**Re: CHICK-FIL-A**  
**5031 Montgomery Blvd. NE**  
**Traffic Circulation Layout**  
Engineer's Stamp 04-09-24 (F17-D034)

Based upon the information provided in your submittal received 04-19-24, the above referenced plan cannot be approved for Building Permit until the following comments are addressed:

C-2.0

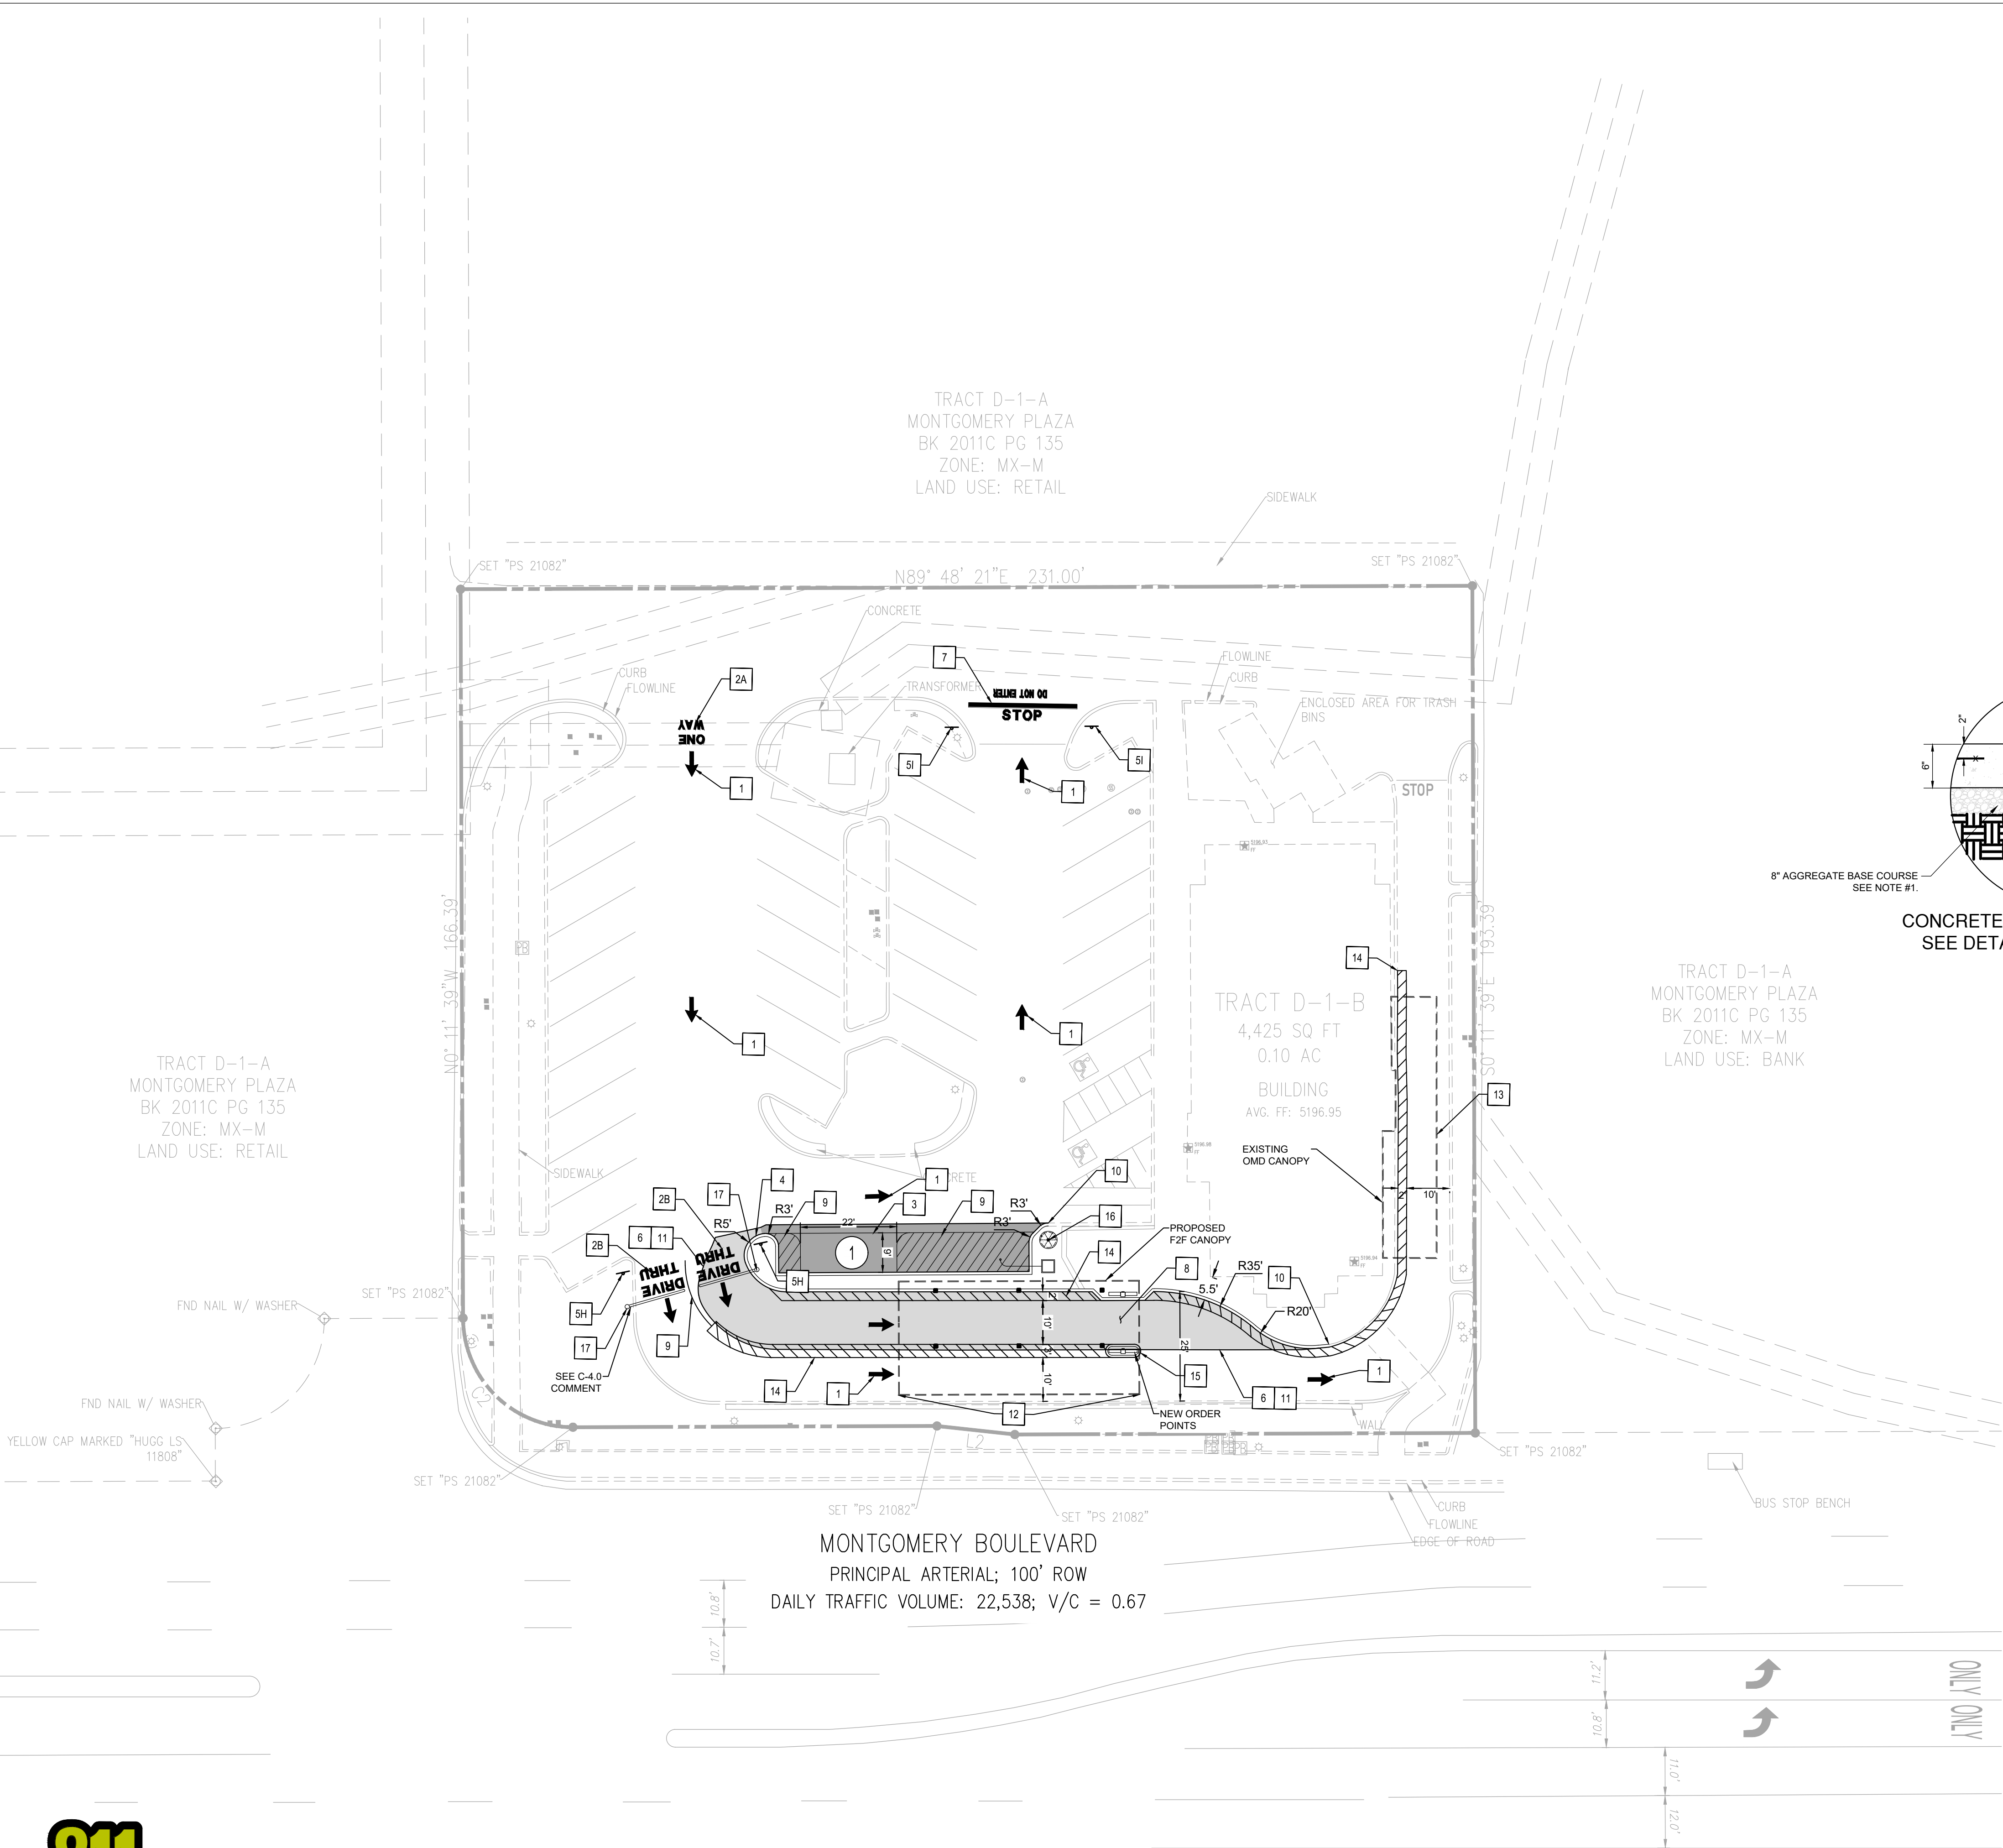
1. Please show a vicinity map on the site plan sheet C-2.0 showing the location of the development in relation to streets and well-known landmarks.
2. List the number of Motorcycle and Bicycle parking spaces required by the IDO.
3. Please show on the site plan, the required stacking spaces for the drive-thru lanes.
4. Please list the degree, width and length for all existing parking spaces. Some dimensions are not shown. See attached Angled Parking dimensions requirements for reference.
5. Show on the site plan the existing drive aisles width.

6. The ADA accessible parking sign must have the required language per 66-7-352.4C NMSA 1978 **"Violators Are Subject to a Fine and/or Towing."** Please call out detail and location of signs.

7. The ADA access aisles shall have the words **"NO PARKING"** in capital letters, each of which shall be at least one foot high and at least two inches wide, placed at the rear of the parking space so as to be close to where an adjacent vehicle's rear tire would be placed. (66-1-4.1. B NMSA 1978)

8. Please provide all the existing ADA ramps details (width, running and cross slopes). ADA curb ramps must be updated to current standards and have truncated domes installed.

9. The pavement marking "MC" should be shown in the opposite direction for motorcycles entering the parking space.
10. All bicycle racks shall be designed according to the following guidelines:

11. Bicycle racks shall be sturdy and anchored to a concrete pad.
12. A 1-foot clear zone around the bicycle parking stall shall be provided.
13. Bicycle parking spaces shall be at least 6 feet long and 2 feet wide.

14. Please show on the site plan these dimensions.

15. The minimum drive through lane width is 12 feet with a 25-foot minimum radius (inside edge) for all turns. (A 15-foot radius can be used with an increase in lane width to 14 feet). Please dimension all lane widths and radii.

16. Add a note stating "All broken or cracked sidewalk must be replaced with sidewalk and curb & gutter." A build note must be provided referring to the appropriate City Standard drawing.
17. Traffic Studies: See the Traffic Impact Study (TIS) thresholds. In general, a minimum combination of 100 vehicles entering and exiting in the peak hour warrants a Traffic Impact Study. Visit with Traffic Engineer for determination, and fill out a TIS Form that states whether one is warranted. In some cases, a trip generation may be requested for determination (**Contact Matt Grush: [mgrush@cabq.gov](mailto:mgrush@cabq.gov)**).
